Nomination Form
Anadromous Waters Catalog

Anadromous Waters Catalog Number of Water Body 114-31-10130-2051

114-31-10130 Tributary 7

ADDITION

Figure 4.—114-31-10130 tributary 7 addition map.

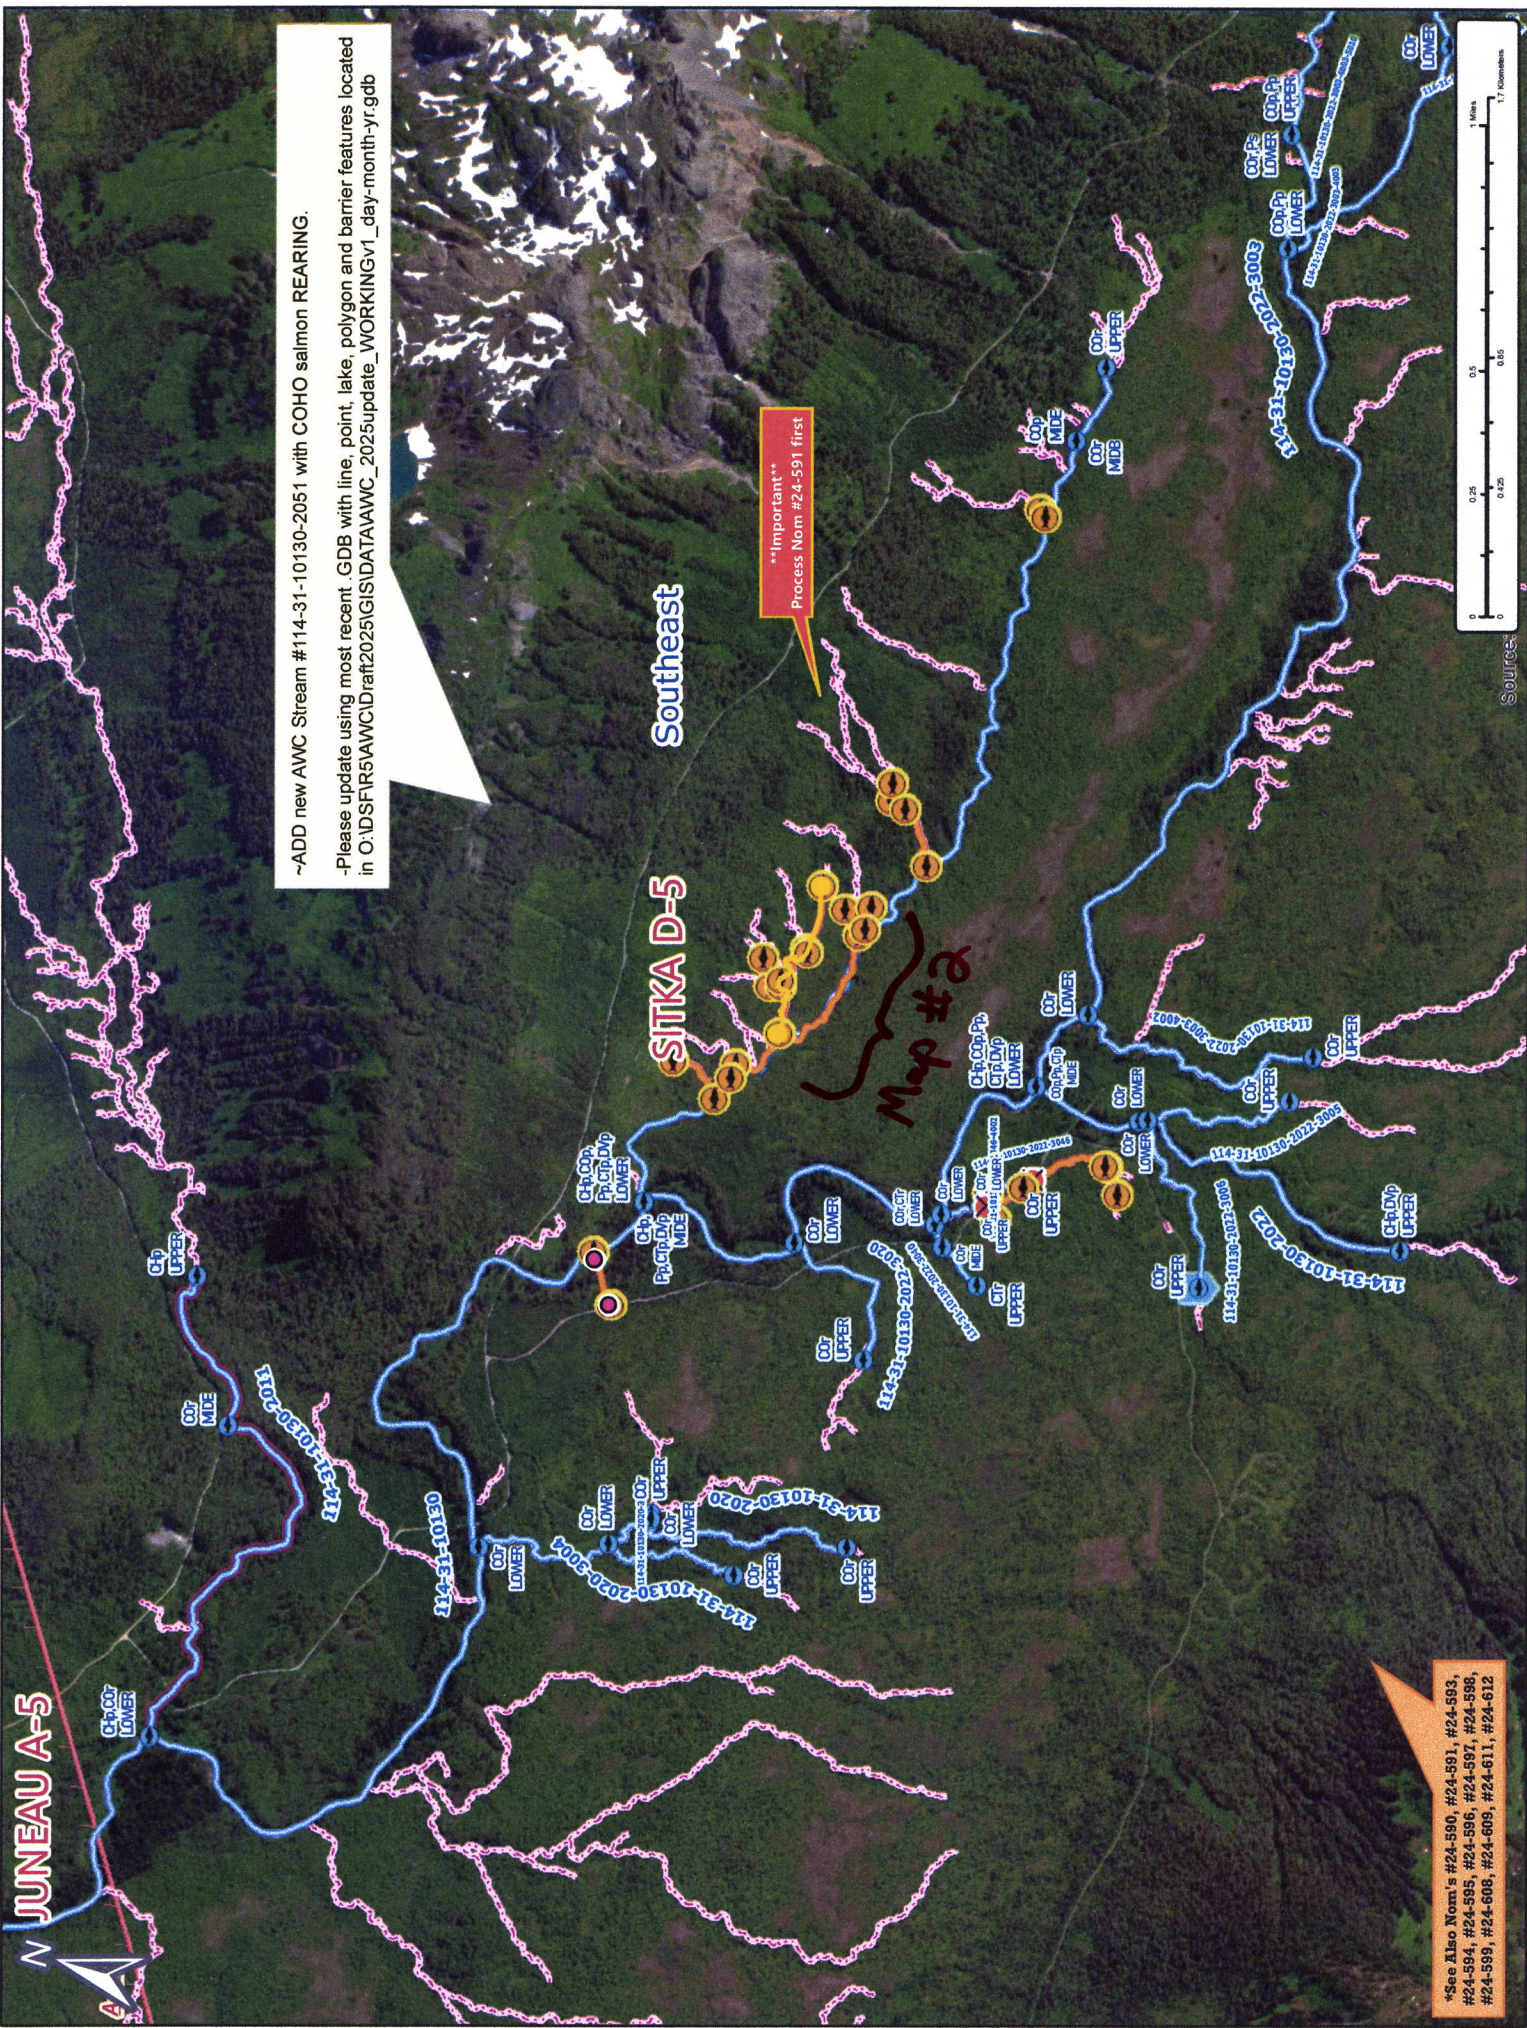
Recommendations: Add this uncataloged stream to the anadromous waters catalog for rearing coho salmon (Figure 4).

~ADD new AWC Stream #114-31-10130-2051 with COHO salmon REARING.
-Please update using most recent .GDB with line, point, lake, polygon and barrier features located in O:\D:\SF\RAWC\Draft2025\GIS\DATA\AWC_2025update_WORKINGv1_day-month-yr.gdb
